Subject: Duke Energy Carolinas, LLC.  
William States Lee III Nuclear Station - Docket Nos. 52-018 and 52-019  
AP1000 Combined License Application for the William States Lee III  
Nuclear Station Units 1 and 2  
Response to Request for Additional Information  
(RAI Nos. 907, 908 and 925)  
Ltr # WLG2008.12-29

**Lee Nuclear Station Response to Request for Additional Information (RAI)**

**RAI Letter No. 019**

FIGURE 6.4-201

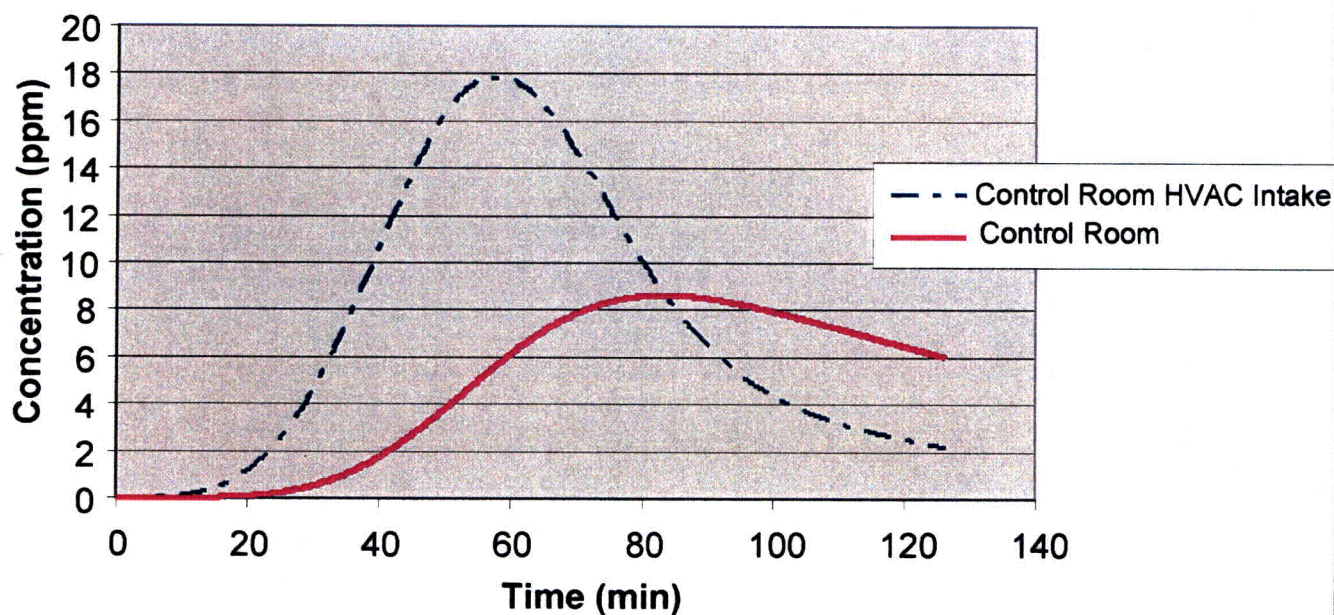
The capability of the control room habitability systems to maintain a suitable environment for prolonged occupancy throughout the toxic gas release, as well as the other events in Chapter 15 is based on the AP1000 assumption of a maximum of 11 operators in the control room. Do plant procedures specify the maximum number of operators allowed in the control room when the habitability systems are intended to protect the control room occupants?

Figure 6.4-201, provided in the Response to RAI 06.04-005, shows that the calculated concentration in the CR reaches a maximum value of 8.6 ppm.

Toxic gas release analysis results for concentration at the control room intake and in the control room are depicted in new Figure 6.4-201 Attachment 2. This figure indicates that the maximum chlorine concentration in the control room remains below 10 parts per million (ppm) and the chlorine cloud at the control room HVAC intake begins to disperse within 1 hour for the modeled conditions. Dissipation to pre-event conditions is expected within a few hours.

FSAR Figure 6.4-201 indicates the concentration of chlorine in the control room assuming no action is taken to isolate the control room envelope from outside air.

As indicated by new FSAR Figure 6.4-201 provided in the response to RAI 06.04-005 of this letter, the maximum concentration of chlorine present in the control room following a postulated worst-case spill, assuming no action to implement protective measures, is calculated to be 8.6 parts per million (ppm).
